Access Compliance Report

Public Rights-of-Way

(Curb Ramps)

Intersection ID: 47979	Main Street: SPRINGS_MILL_RD	Cross Street: RAFFIA_RD	Location: NE
ADA ID: 70FC6365F67D	Ramp Type: PerpDiag	Initial Pass/Fail: Pass	Overall Compliance: No
		Severity Score: 5.25

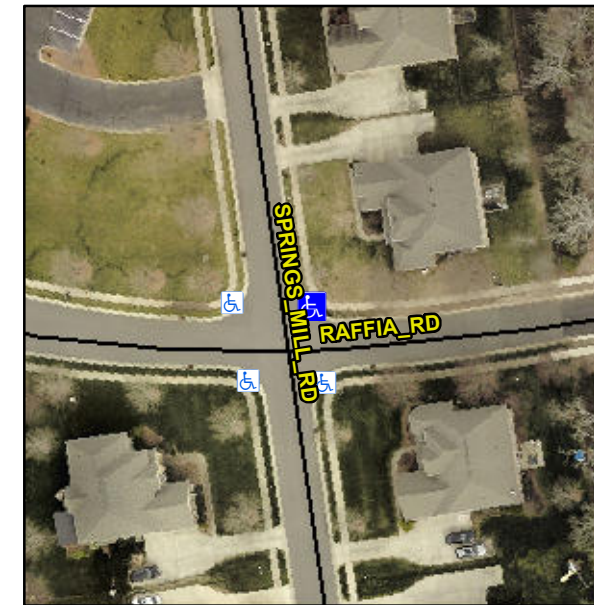
Not Found, R304.5.3, R304.2.1, R304.2.2-Perp, R304.3.2-Para, R305.2, R304.5.4

Compliance	Description	Data	Compliance	Description	Data
N/A	Ramp Length (in)	48.0	Yes	Ramp Slope (%)	5.5
Yes	Ramp Width (in)	48.0	No	Ramp XSlope (%)	3.8
N/A	Flare Type LT	Sloped	N/A	Flare Type RT	N/A
N/A	Flare Slope LT (%)	8.1	N/A	Flare Slope RT (%)	1.0
N/A	Flare Traversable LT?	No	N/A	Flare Traversable RT?	No
No	Landing Length (in)	46.0	Yes	DWS Provided?	Yes
Yes	Landing Width (in)	48.0	Yes	DWS Contrast?	Yes
No	Landing Slope (%)	4.3	Yes	DWS Length (in)	24.0
No	Landing X Slope (%)	3.5	Yes	DWS Full Width?	Yes
N/A	Landing Curb? (Y/N)	No	No	DWS Offset (in)	6.0
N/A	Shared Landing?	No			
Yes	Gutter Ponding?	No	No	Gutter Slope (%)	6.4
Yes	Gutter Lip Ht (in)	0.0	No	Gutter X Slope (%)	6.0
N/A	Painted X Walk1?	No	N/A	Painted X Walk2?	No
	X Walk 1 Direction	To NW		X Walk 2 Direction	To SE
N/A	X Walk 1 Width (in)	N/A	N/A	X Walk 2 Width (in)	N/A
	X Walk 1 Slope (%)	5.9		X Walk 2 Slope (%)	0.3
	X Walk 1 X Slope (%)	1.8		X Walk 2 X Slope (%)	4.8

Remove & Replace Curb Ramp With Two New Directional Ramps or Equivalent. Remove & Replace Gutter.
